## TECHNICAL MEMORANDUM

**Subject: *Tractor Supply Store Project Access Evaluation and Traffic Impact Assessment***

RS18-36233

Figure 1: Project Site Plan

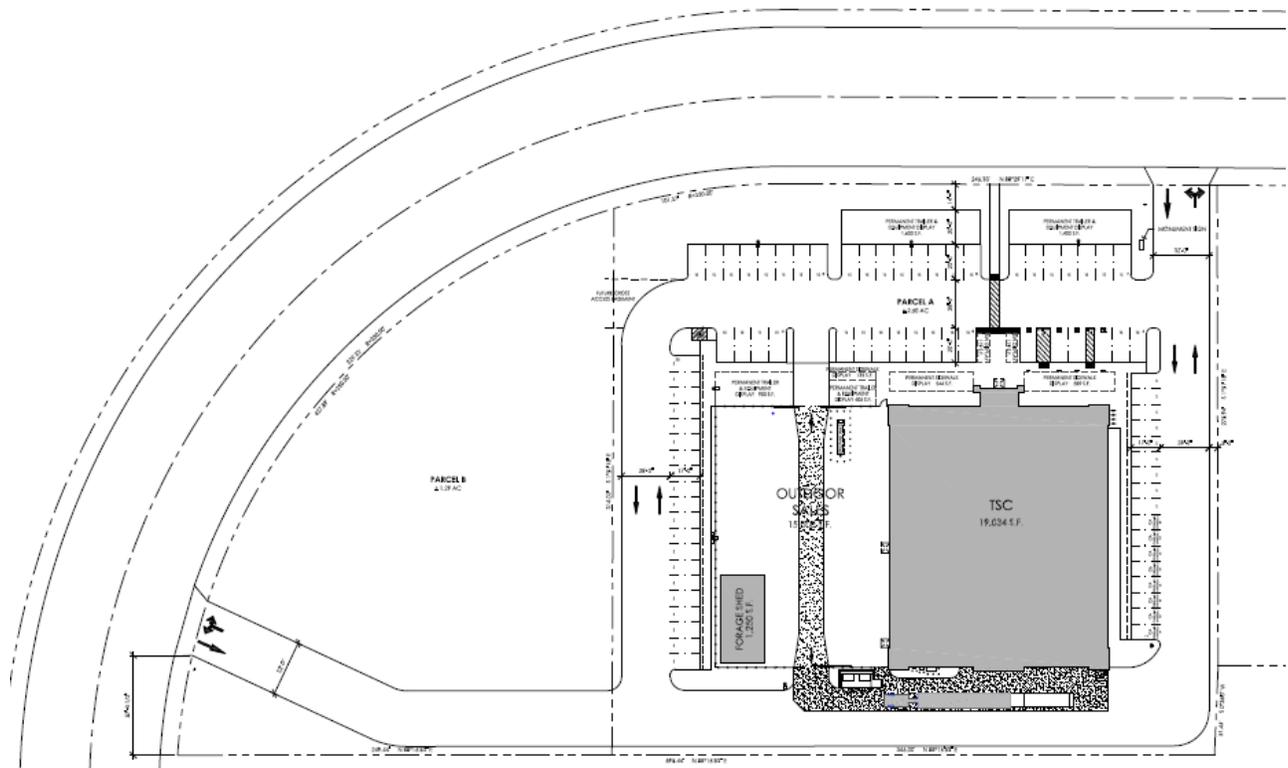
A review of the project site plan did not reveal any inconsistencies of driveways in terms of their spacing, width, and proximity to property lines with applicable City standards as described in *City of Rocklin Improvement Standards and Standard Drawings* (November 2016).

Drawing 3-13 specifies that driveways and intersections located on the inside of horizontal curves with less than a 1,000-foot radius require special design for sight distance subject to approval by the City Engineer. Since Granite Drive features a 400-foot horizontal curvature radius between the two driveways, special sight distance design considerations are warranted.

- **Install a triangular raised concrete median in the Westerly Driveway to physically prohibit outbound left-turns, while permitting inbound left-turns and right-turn movements.**

- **Maintain full-access and stripe one inbound lane and separate outbound left and right turn lanes (controlled by a stop sign).**
